City of Port Phillip
Advertised Plan 1 of 40

28-32 ALBERT ROAD, SOUTH MELBOURNE
DRAWING LIST

AMENDMENTS TO ENDORSEMENT PLANS:

Project Title
28-32 ALBERT ROAD
SOUTH MELBOURNE

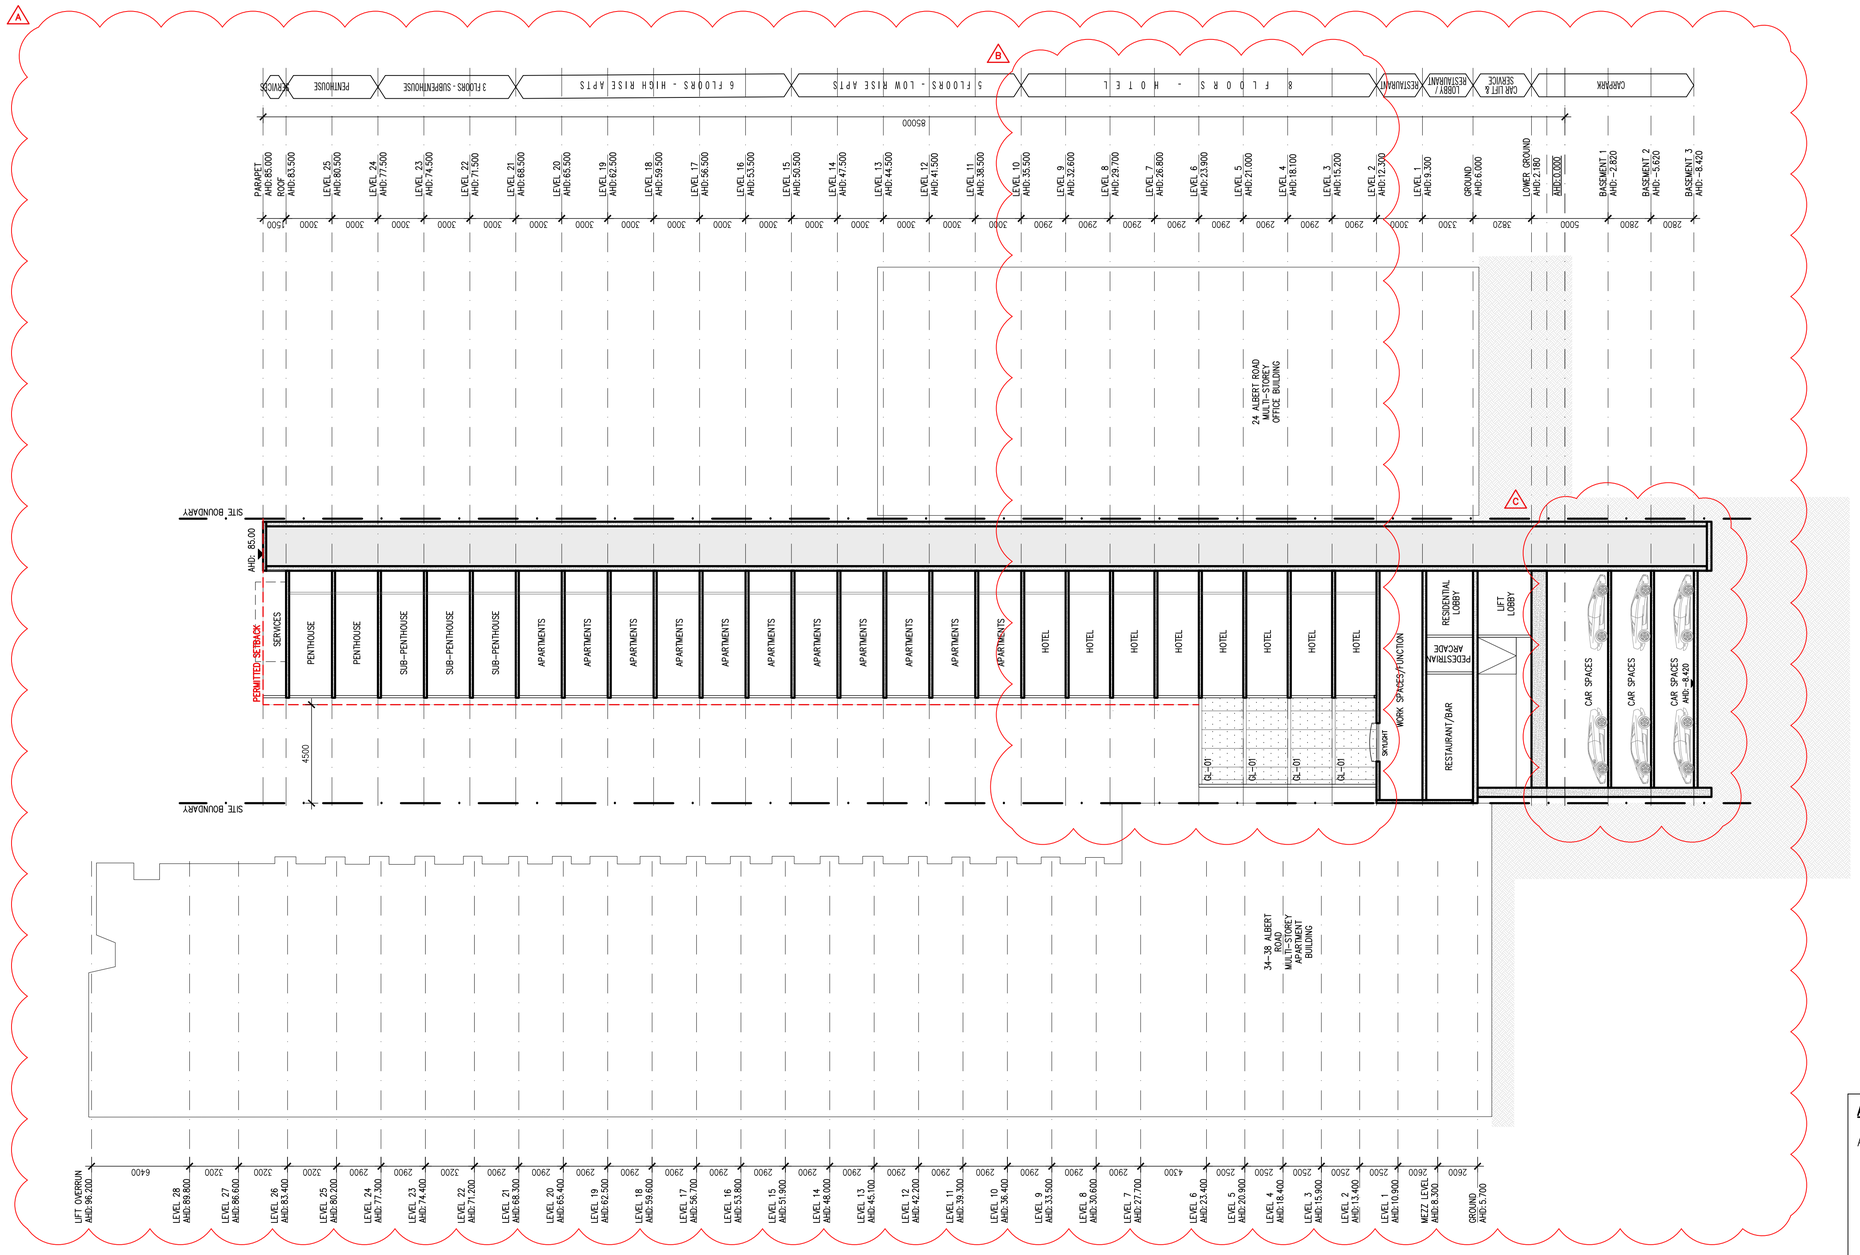
A. FLOOR LEVELS RATIONALISED TO ACCOMMODATE ADDITIONAL LEVEL

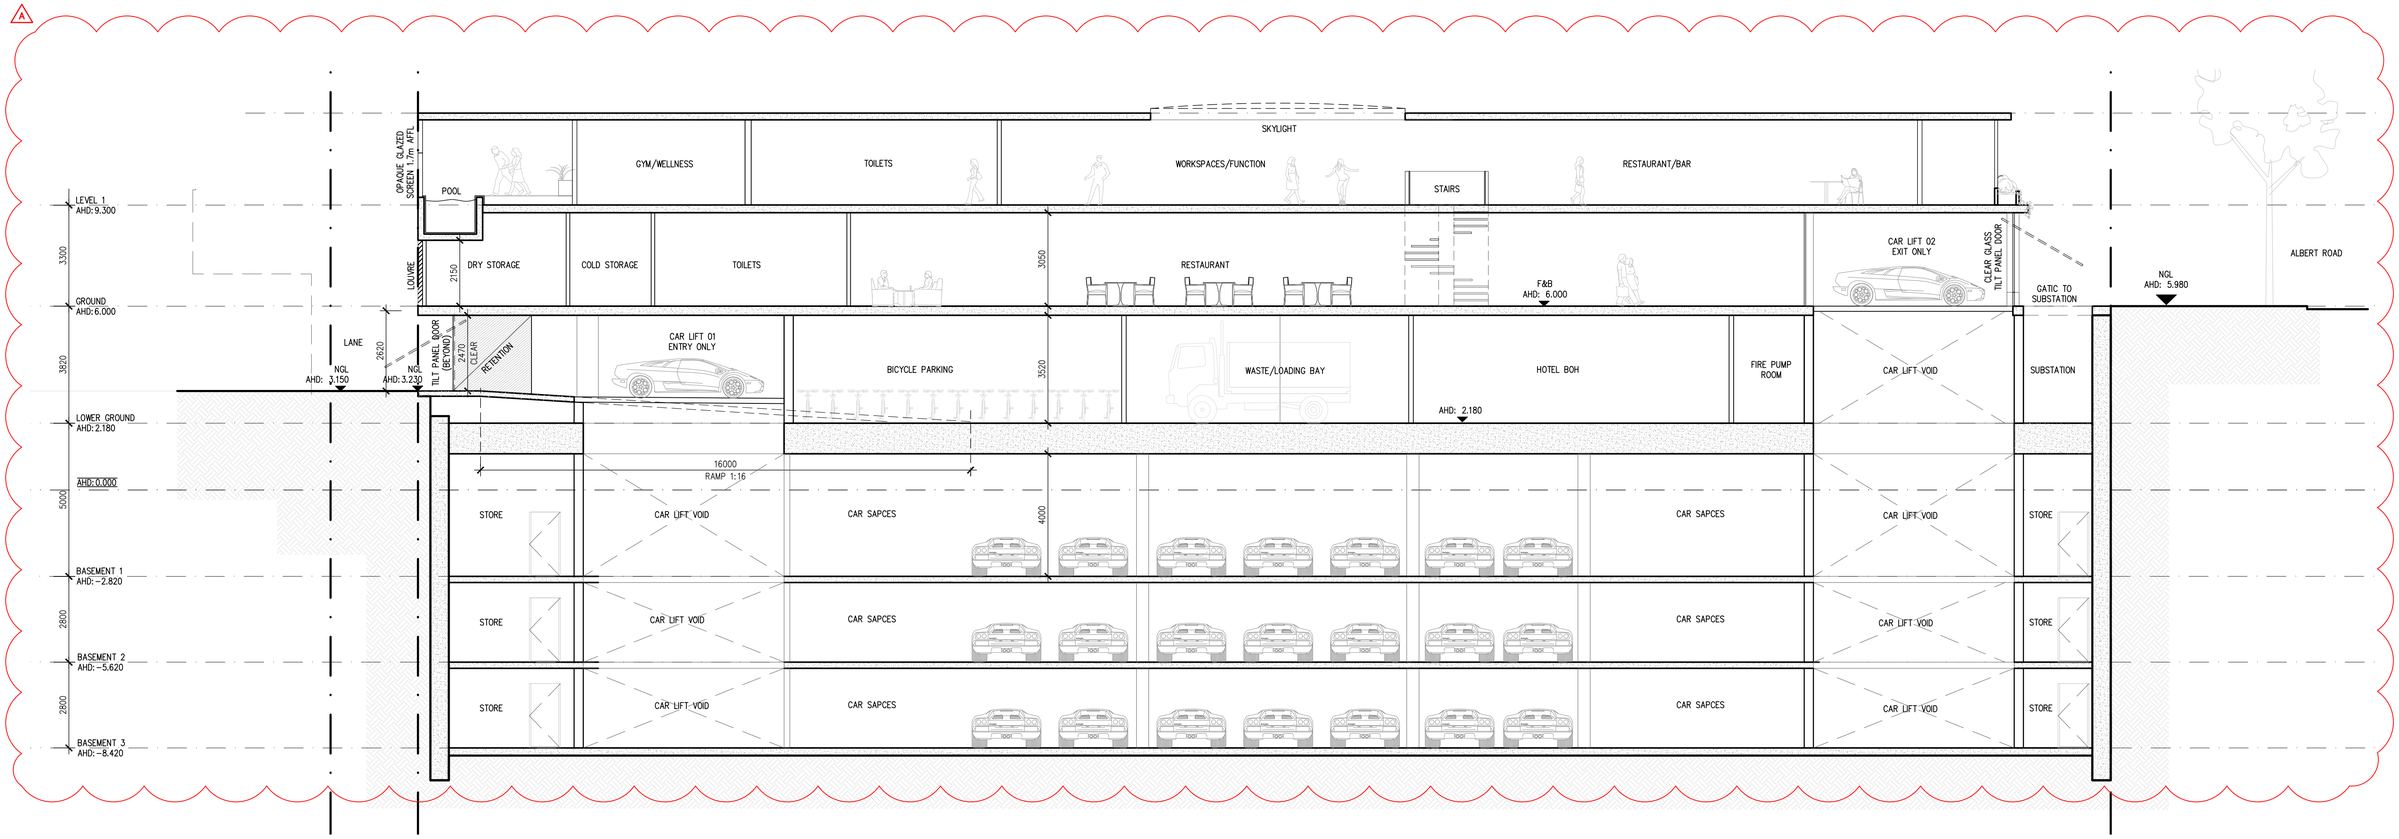
A. FLOOR LEVELS RATIONALISED TO ACCOMMODATE ADDITIONAL LEVEL
